MIL-C-10387J
INTERIM AMENDMENT 1(ME)
2 February 1994

MILITARY SPECIFICATION

COUPLINGS, CLAMP, PIPE; WITH BOLTS AND SYNTHETIC-RUBBER GASKETS

FOR GROOVED-END PIPE

"6.4 Part or identifying number (PIN). The PIN to be used for couplings covered acquired to this document are created as follows (see 6.2):

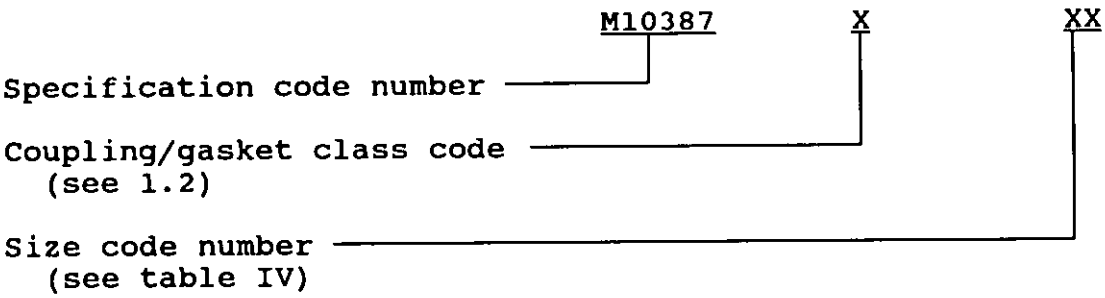
6.4, delete in its entirety and substitute:

Example: M10387A05 couplings of aluminum alloy and 2 inches in size, conforming to MIL-C-10387."
